2.2 Control and Instrument Systems

The information in this section of the reference ABWR DCD, including all subsections, tables, and figures, is incorporated by reference with the following departures.

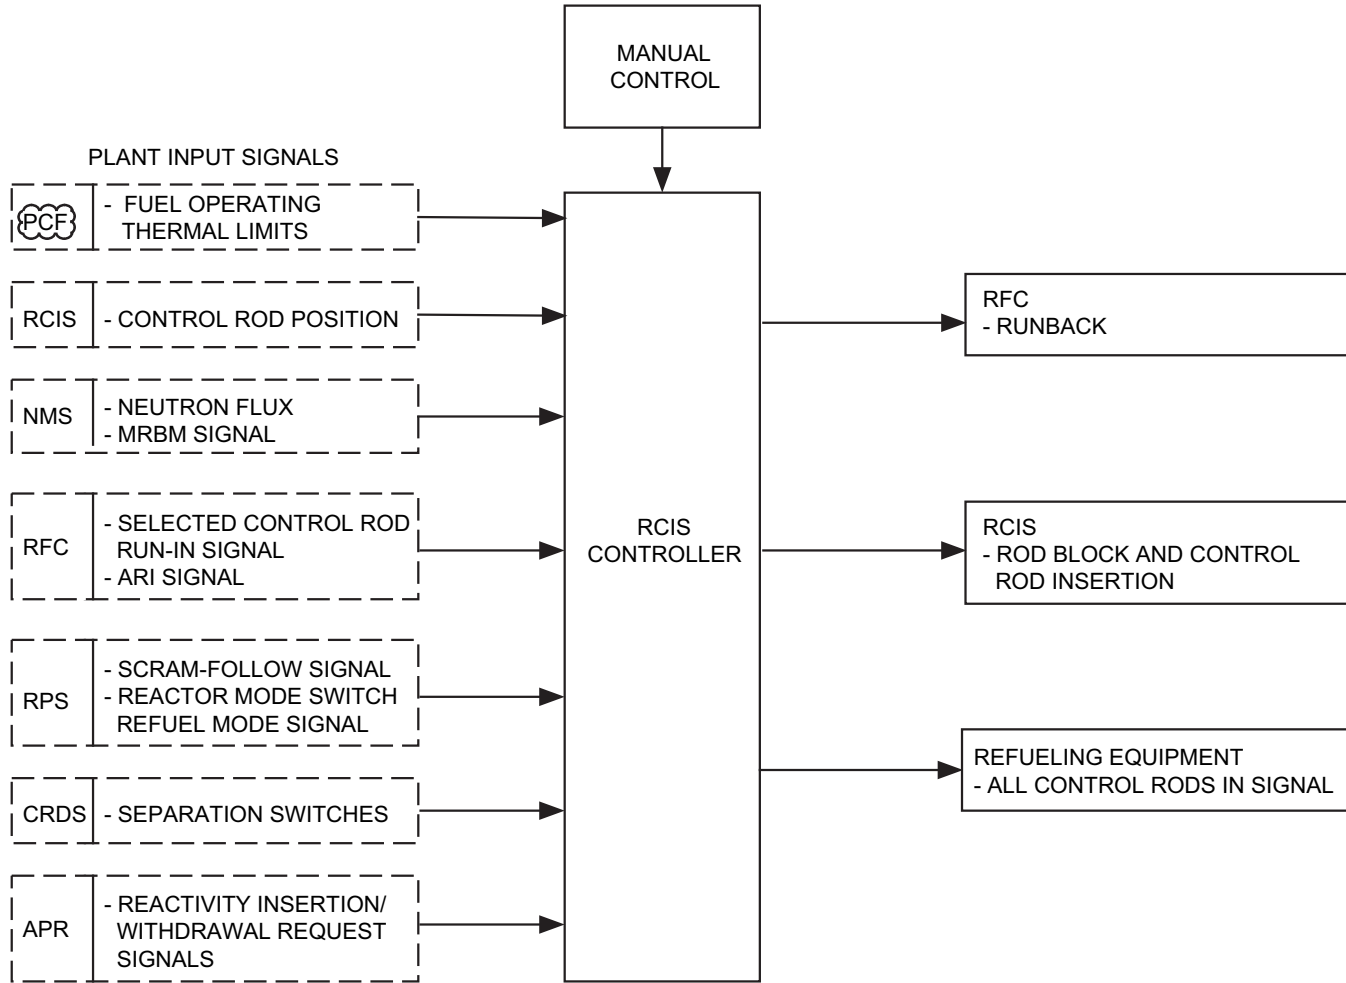
STD DEP T1 2.14-1 (Figure 2.2.6)

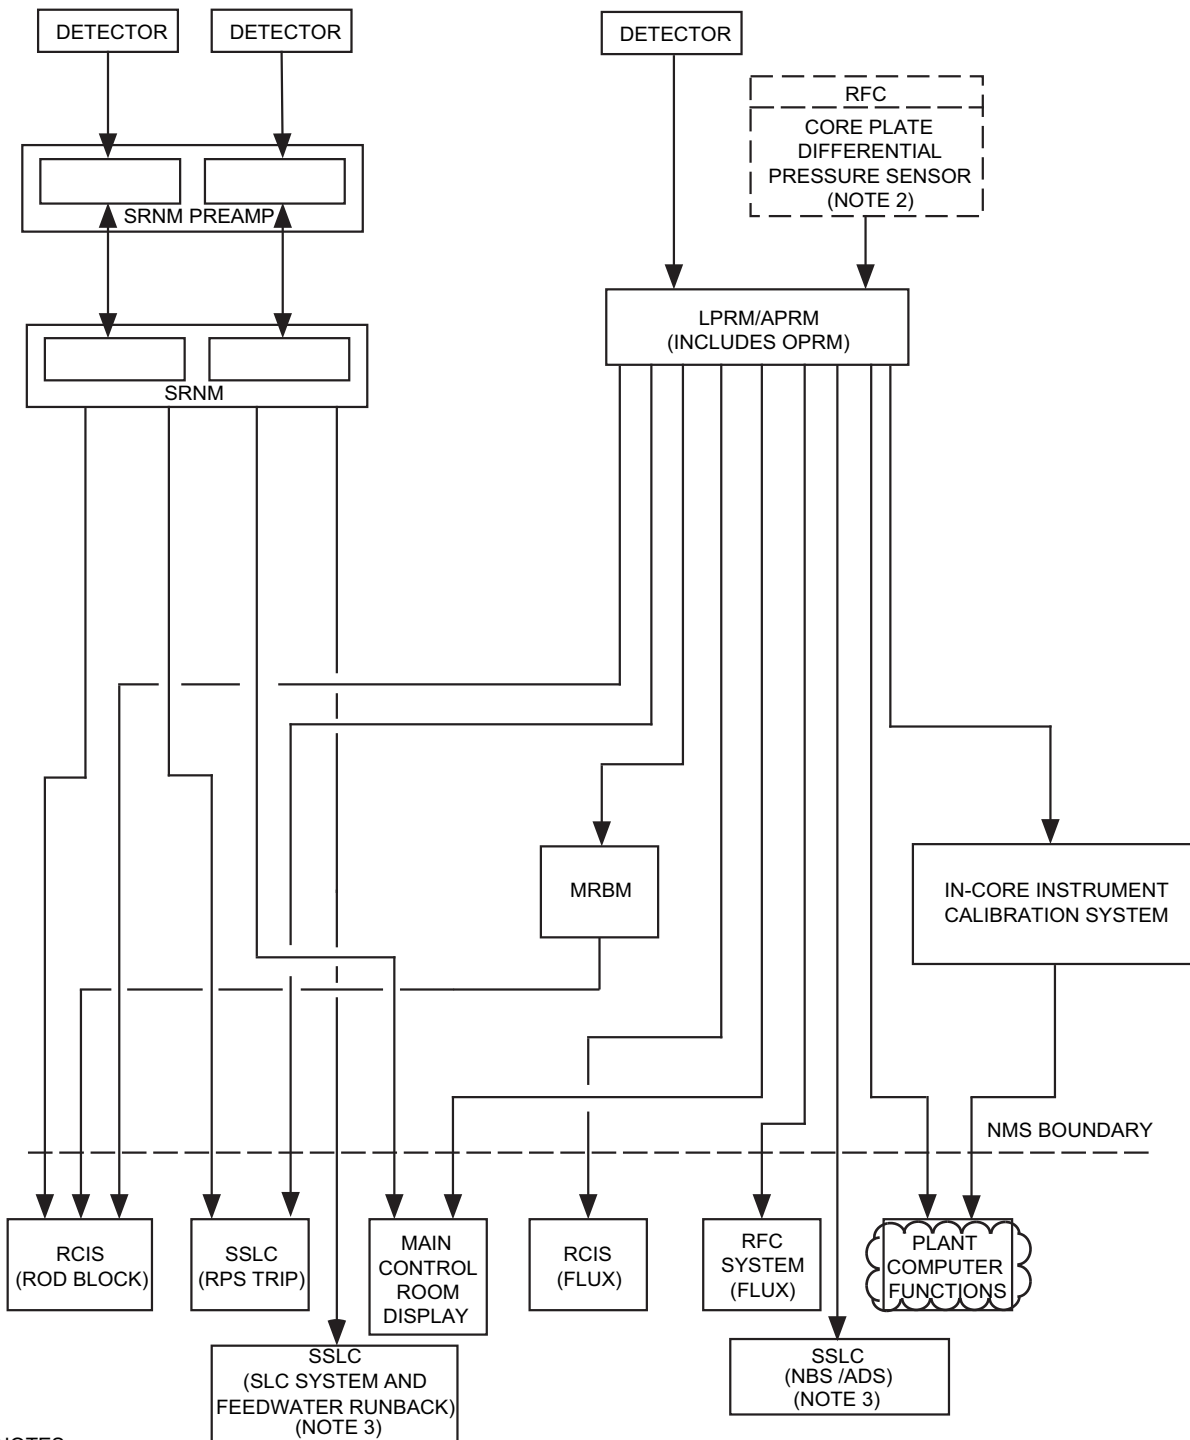
The FDWC digital controllers determine narrow range level signal using three reactor level measurement inputs from the NBS. ~~Sensor signals are transmitted to the FDWC digital controllers by the Non-Essential Multiplexing System (NEMS).~~

The steam flow in each of four main steamlines is sensed at the RPV nozzle venturis. ~~Sensor signals are transmitted to the FDWC System digital controllers by the NEMS.~~ These measurements are processed in the digital controllers to calculate the total steam flow out of the vessel.

Feedwater flow is sensed at a flow element in each of the two feedwater lines. ~~Sensor signals are transmitted to the FDWC digital controllers by the NEMS.~~ These measurements are processed in the digital controllers to calculate the total feedwater flow into the vessel.

~~The total feedwater flow is displayed on the main control panel. The FDWC System operating mode is selectable from the main control room. The FDWC System microprocessors are located in the Control Building.~~

Figure 2.2.6 Remote Shutdown System

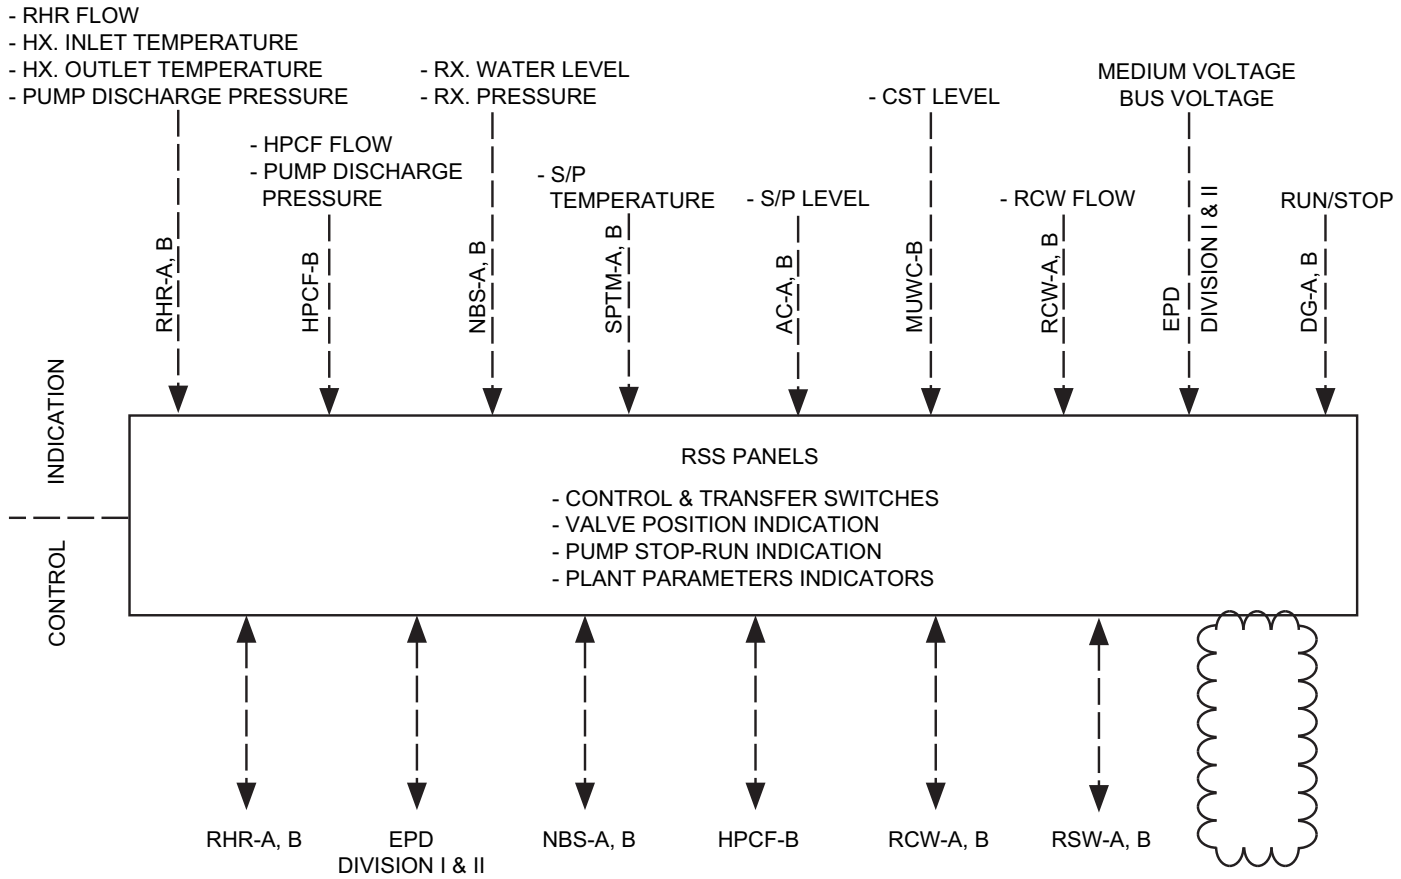
STD DEP T1 2.14-1 (Figure 2.2.6)

- (10) ~~Flammability Control System (FCS)~~ Not used

Figure 2.2.7b Reactor Protection System

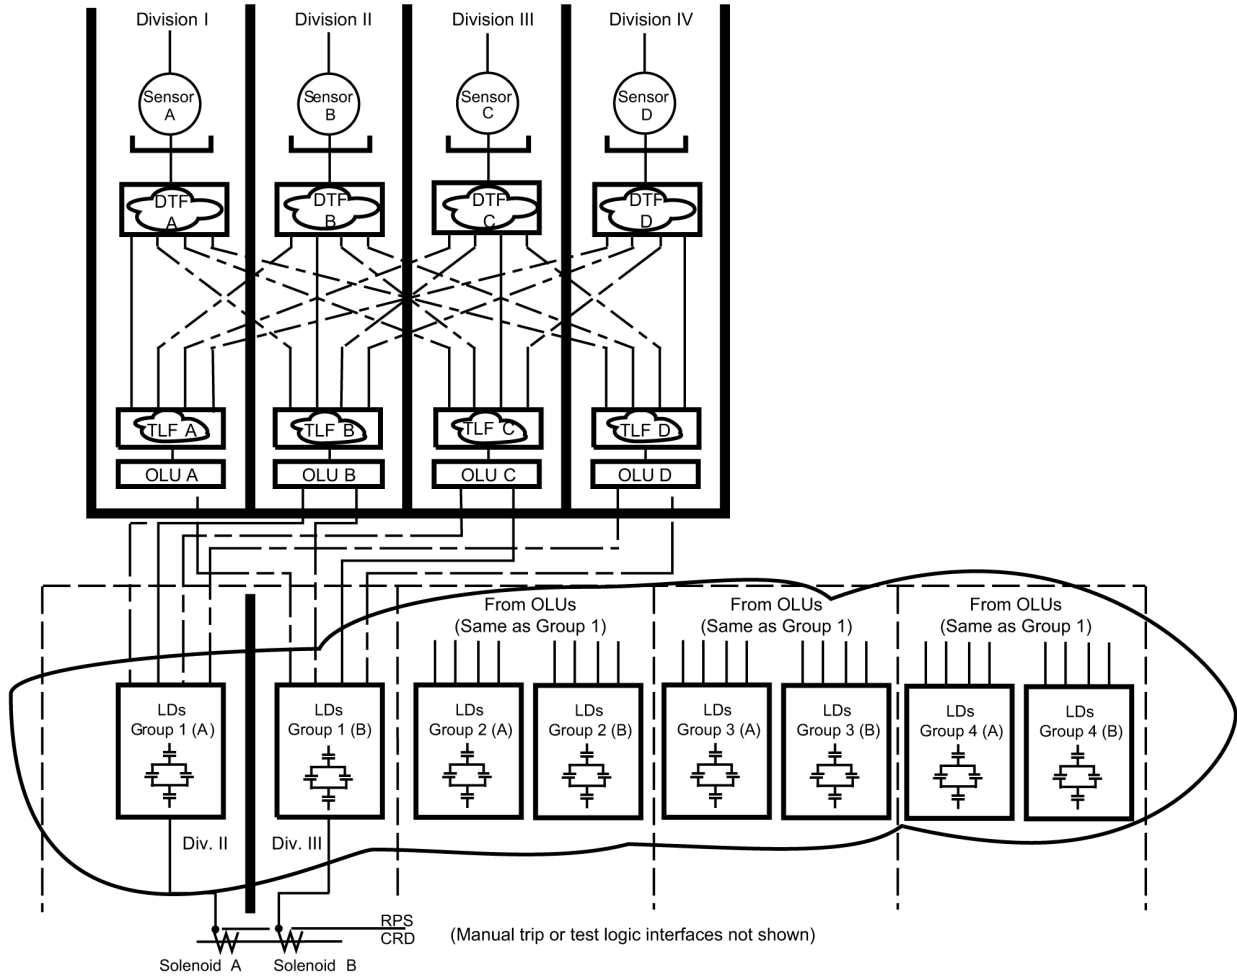
STD DEP T1 3.4-1 (Figure 2.2.7b)

The RPS has four divisions. Figure ~~2-2-6a~~ 2.2.7b shows the RPS divisional aspects and the signal flow paths from sensors to scram pilot valve solenoids. Functions Equipment within an RPS division consists of include sensors (transducers or switches), I/O, multiplexers, data communication, digital trip modules functions (DTM DTF), trip logic unit function (TLU TLF), output logic unit (OLU), and load drivers (LD). The LDs are only in Divisions II and III. The (DTF) and (TLF) are performed in digital configurable logic devices. The data communication functions are described in Section 2.7.5.

The RPS consists of logic and circuitry for initiation of both automatic and manual scrams. The automatic scram function is ~~comprised of~~ accomplished redundantly in four independent divisions of sensor instrument channels, hardware/software based logic and logic processing, and two independent divisions of actuating devices. Automatic scram is initiated whenever a scram condition is detected by two or more automatic divisions of RPS logic. For automatic scram, the sensor input signals to the RPS originate either from the RPS's own sensors or other systems' sensors. For determination of the existence of an automatic scram condition, within each automatic scram channel division of the RPS, the DTM DTF of a given RPS channel division compares the monitored process variable with the a stored setpoint stored in its memory and issues a trip signal if the monitored process variable exceeds the setpoint. The DTM DTF then sends the trip signal to the TLU TLF of its own channel division and the TLU TLFs of the other three channels divisions of RPS, where two-out-of-four voting is performed (see Figure 2-2-6a). The TLF in each division performs an independent two-out-of-four vote on each RPS DTF input.

The ~~TLU~~ TLFs provide their trip signals to their divisional OLUs which ~~are used to~~ control the solid-state LDs that control the Class 1E AC power to the scram solenoids, and relays that control DC power to back-up scram valves. For automatic scram initiation, the ~~TLU~~ TLF trip signals cause the LDs to interrupt Class 1E AC power to the scram solenoids (fail-safe logic), cause the back-up scram relays to supply DC power to back-up scram solenoids, and provide scram follow signals to the RCIS. Each division of RPS controls eight LDs. The LDs are arranged to switch AC power to the scram solenoids in a two-out-of-four ~~format~~ arrangement. That is, reactor scram will occur only if two or more divisions of the RPS provide trip signals to their associated LDs and both scram solenoids are de-energized.
